UNITED STATES PATENT AND TRADEMARK OFFICE

Office Action Summary	Application No. 10/509,939	Applicant(s) NIKANDER, RISTO
	Examiner JASON L. LAZORCIK	Art Unit 1791

DETAILED ACTION

FIG. 1

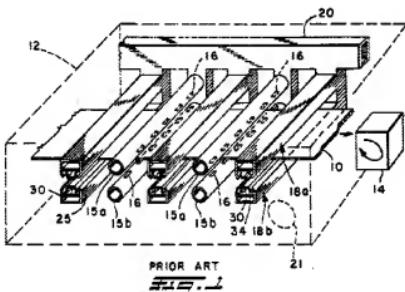
With particular reference to the instant figure 1, Hoetzl '483 teaches a method for transferring a heat softened glass sheet from a rotating roller bed (19) in an oven (18) to a bending ring mold (80 – see fig 8) in a press station (21). The transfer is conducted at a "a horizontal height level" or "without vertical oscillations" (Column 4, lines 33-35) from a position in the oven where the glass is supported by the rollers to a position in the region of the furnace exit wherein the roller support is terminated and the sheet is

thereafter gradually supported from below by dynamic air support from pressure pads directed against the bottom surface of the glass sheet (Column 13, lines 24-52). Said pressure pads are construed to read upon the arrangement of various nozzles which are located at a distance from the glass sheet and which direct air flow against the glass sheet thereby producing glass sheet supporting air jets as recited in Claim 1.

Regarding the transfer process, the '483 reference teaches that "when the glass sheet reaches the furnace exit, a glass run out section of the roll drive goes to high speed and this causes the glass to transfer to dumper pad(s) (82)" (Column 13, lines 25-28). The Examiner construes the latter excerpt as an indication that there exists at least a nominal transfer force between the last one of said rotating rollers (19) and the glass sheet during the transfer of said sheet from the roller bed to the bending ring.

In the '483 embodiment, the glass sheet is supported by and guided downstream on an air cushion formed by directing an air flow onto a bottom surface of the glass sheet. Once the glass sheet arrives at the location of a bending ring, conveyance of the glass sheet is stopped by a "conventional guide/stop drive arrangement". The suspended glass sheet is subsequently lowered into contact with the ring mold by "lowering the pressure pads" (Column 13, lines 53-67) as a nozzle system and/or by reducing the air flow.
